66 Cumnor Hill Oxford	Feb 2013
Residential Development	1:200@A1
Proposed Site Plan	2013007
	P.02

CONSULTATION WITH CUMNOR PARISH COUNCIL

Application reference:	P13/V0626/FUL	Officer:	Martin Deans
Application type:	Major	Amended plans:	
Address:	66 Cumnor Hill, Oxford OX2 9HB		
Proposal:	<i>Demolition of existing dwelling. Erection of 11 x 2 bed flats and 1 x 1 bed flat in three separate two and three storey buildings. Alterations and extension to existing access, 20 car-parking spaces, cycle parking, bin storage and landscaping.</i>

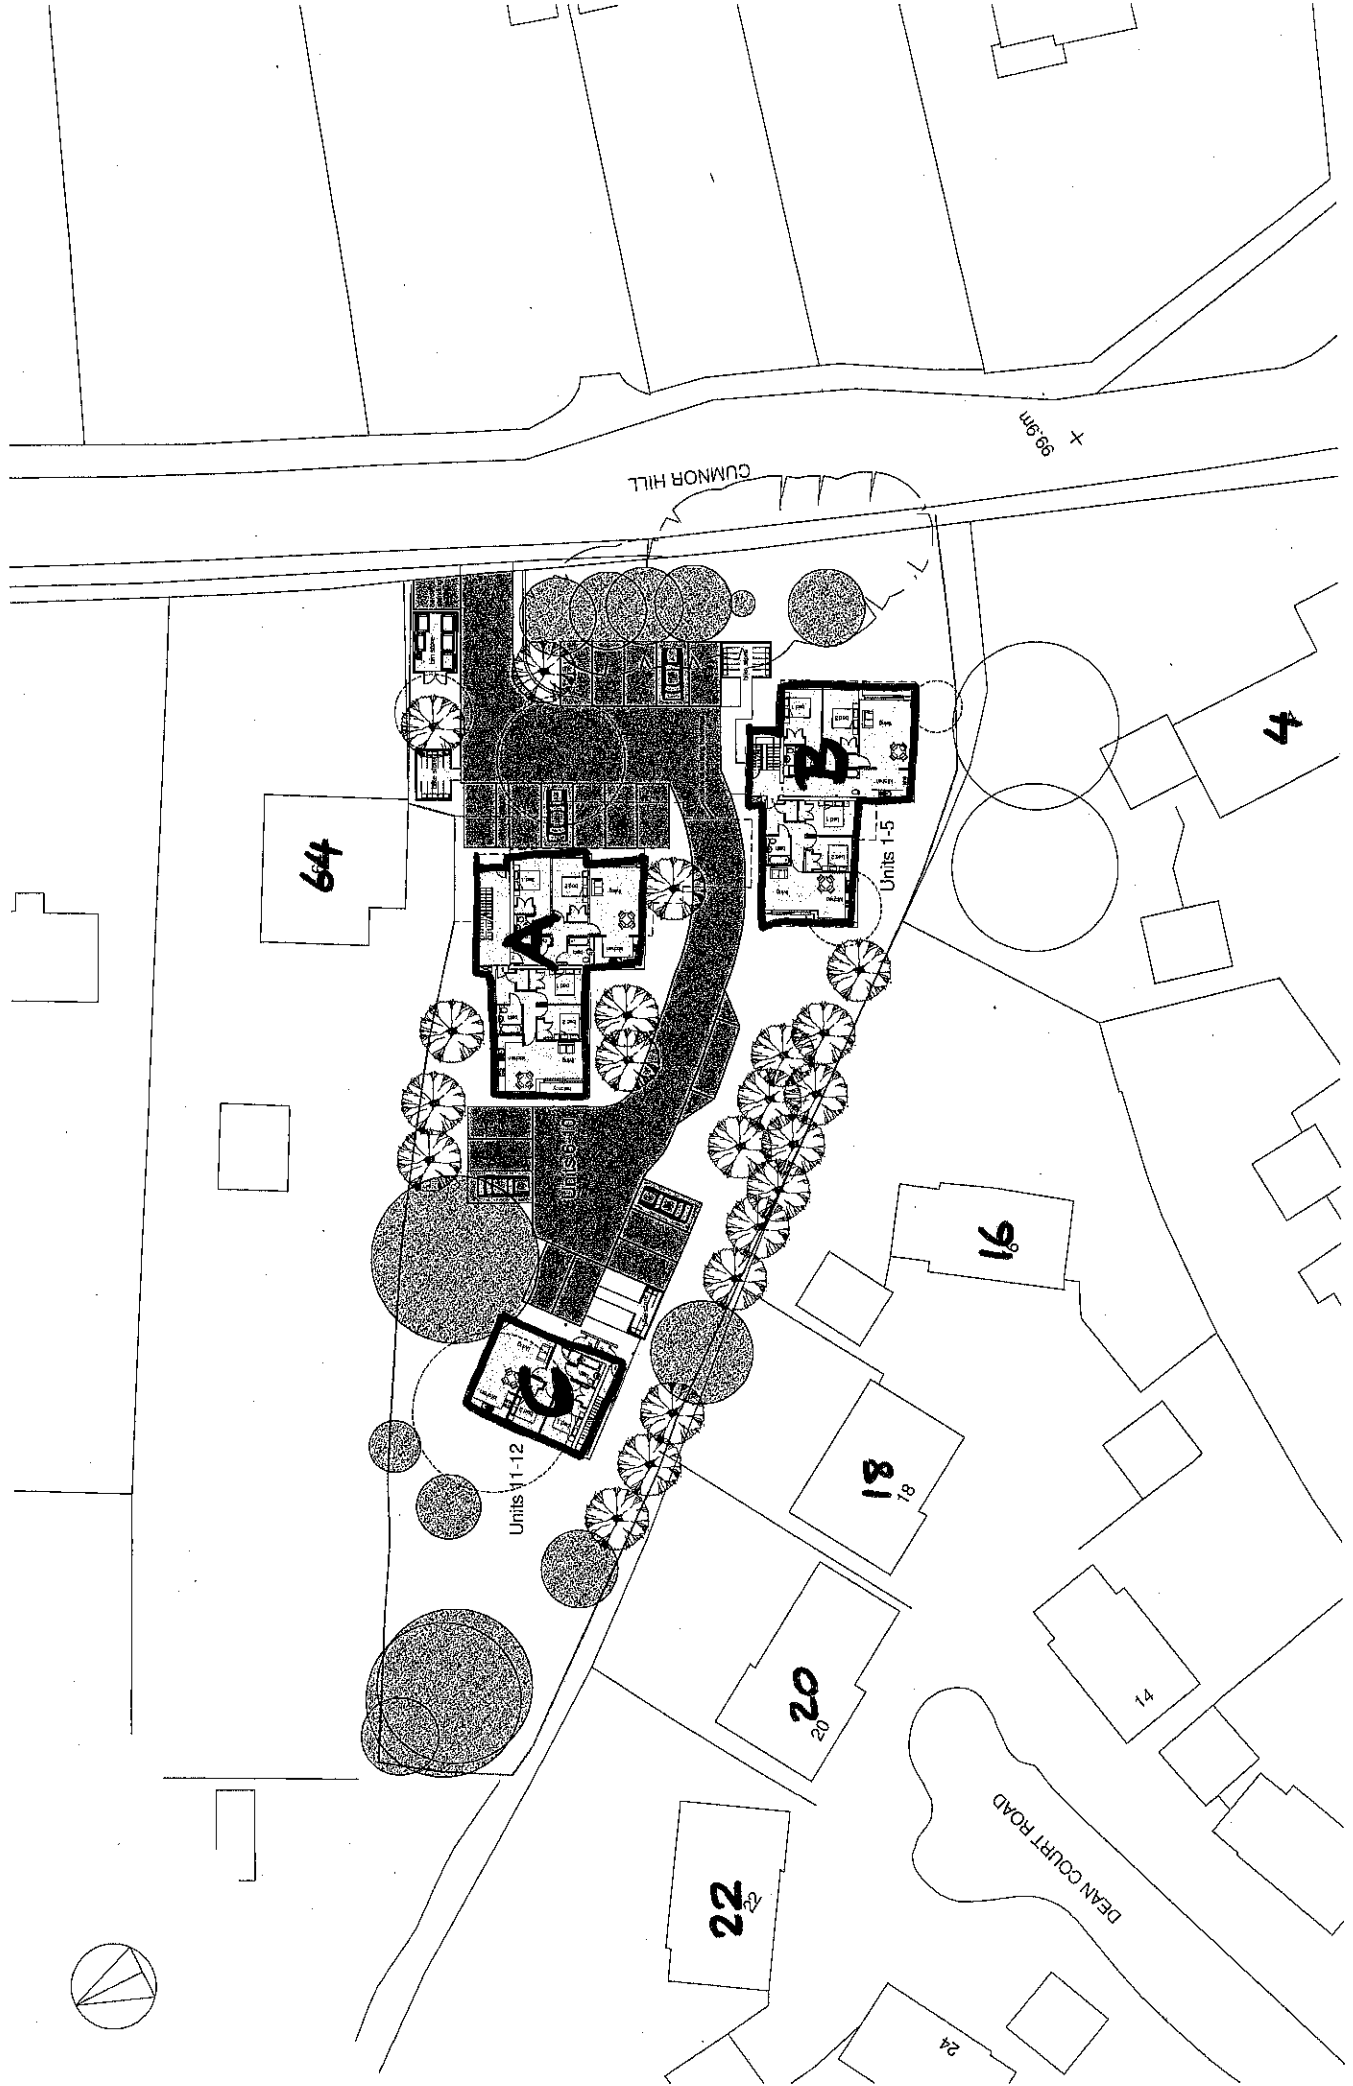
Density: The density of the proposal at 44 dwelling per hectare is excessive compared to a local average of 10.5 dwellings per hectare. Such a density would be completely out of character in this location and would create an over-dominant effect on neighbouring properties.

Access: The access to the site is very close to the nearby bus-stop and Council asks that the arrangements for the entrance to the site be reviewed to ensure the safety of the large number of people who use the bus-stop, bearing in mind the volume of traffic that a proposal of this size would generate.

Feb 2013	1:100 @ A1	2013007	P.04
66 Curmorr Hill Oxford		Residential Development	Units 6-10

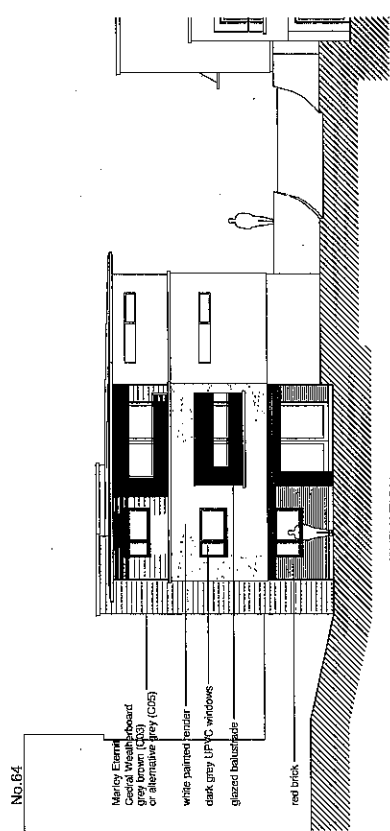
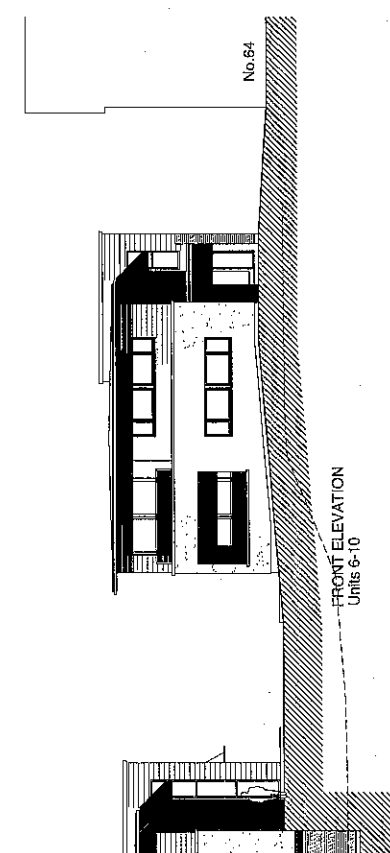
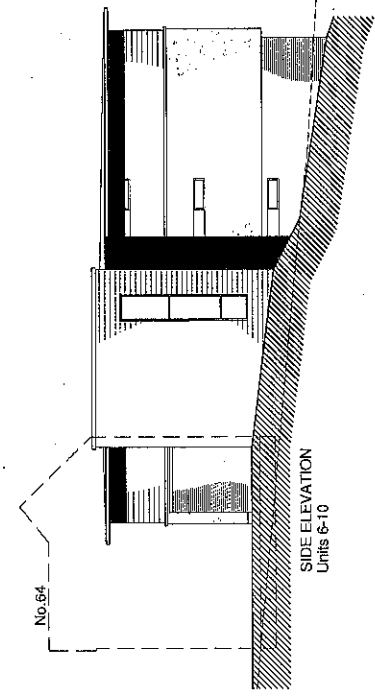
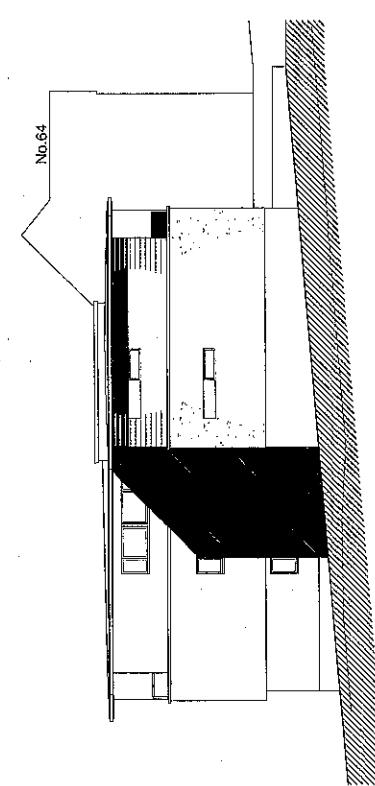
Effects on neighbouring properties: Council notes that No.64 Cumnor Hill has three windows and a patio on its elevation adjacent to the site. This proposal would inevitably lead to an unacceptable loss of light, overlooking and loss of privacy. Properties in Dean Court Road will be immediately overlooked by the three storey apartment blocks.

PROPOSALS:
 BLOCK PLAN

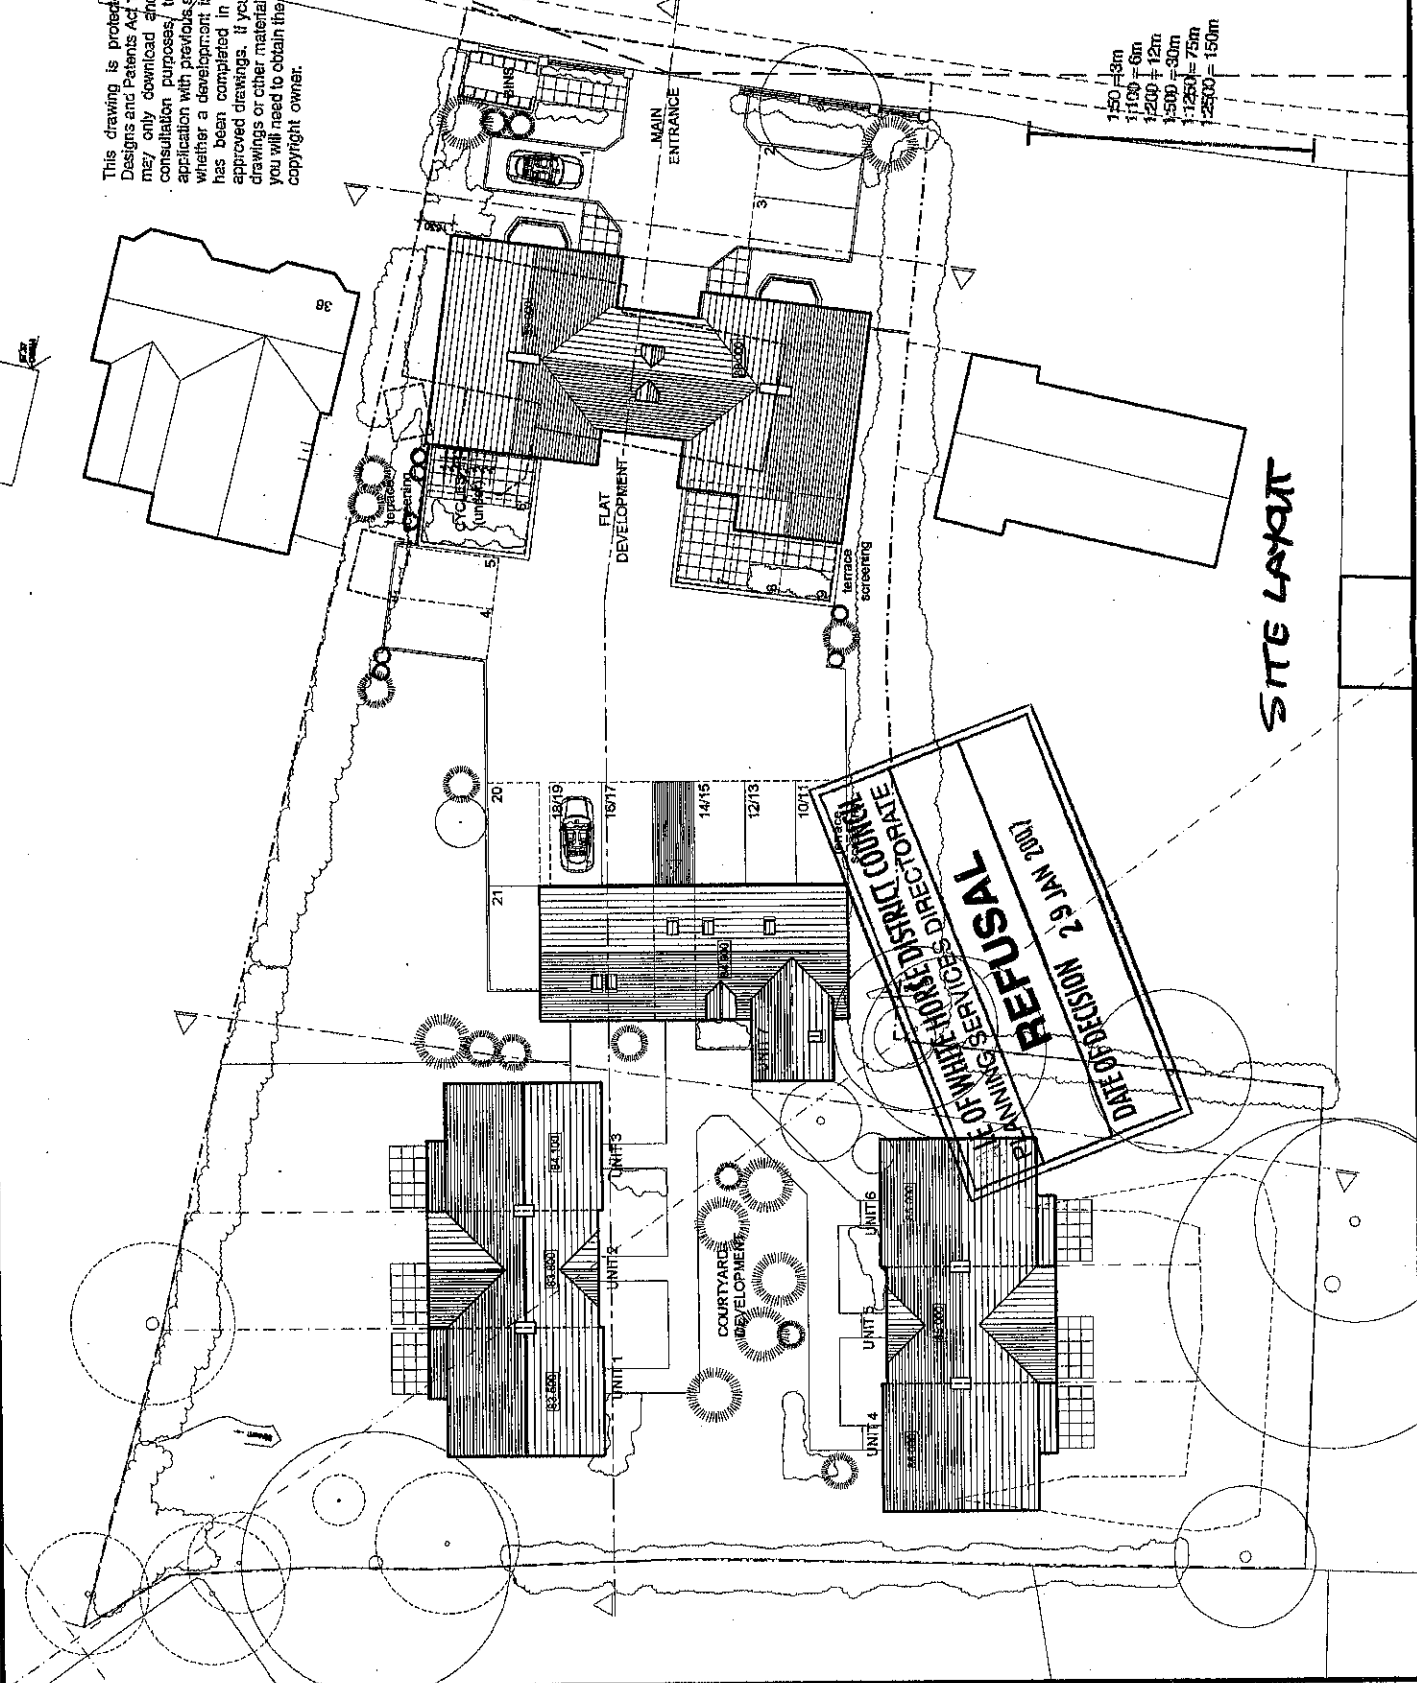
11. The proposed front block would be in a slightly forward position compared to the existing dwelling, and whilst it would be higher than the neighbouring house at No 36, I do not consider that this matters unduly in terms of local character. It would also fill much of the width of the plot, being significantly wider than the existing house. There is variety in house size in the road; some are notably higher than their neighbours and some fill the width of their plots. Some properties do not have well landscaped front gardens, but these are the exception to the general character.

12. However, it is the combination of the design, its height, and full width across the plot, which I feel would make the building unacceptably dominant. The block would appear as two large, tall dwellings, with a prominent third storey in the roof, linked by a high roof over a central archway. There is nothing of similar character on the hill. Added to this would be a large hard-surfaced area between the block and the road providing parking and bin stores, leaving only a small area for landscaping.

13. Notwithstanding the variety of houses in the road, I consider that the combination of these features would give the impression of a highly urban form of development, markedly out of keeping with the characteristic houses and their setting in the area. Thus, I consider that the Council's arguments on this issue are the stronger, and form a strong reason for dismissing the appeal.

17. The house at 36 Cumnor Hill has a first floor bedroom window facing the appeal site, which would look out over a raised terrace. Even taking into account that the house at No 36 is at a lower level than the appeal site, I am satisfied that the combination of screening and distance from the window would ensure that there would not be a harmful loss of privacy. The outlook from that window would be slightly further restricted, but even so, there would still remain what I consider to be a satisfactory outlook over the rear of the site.
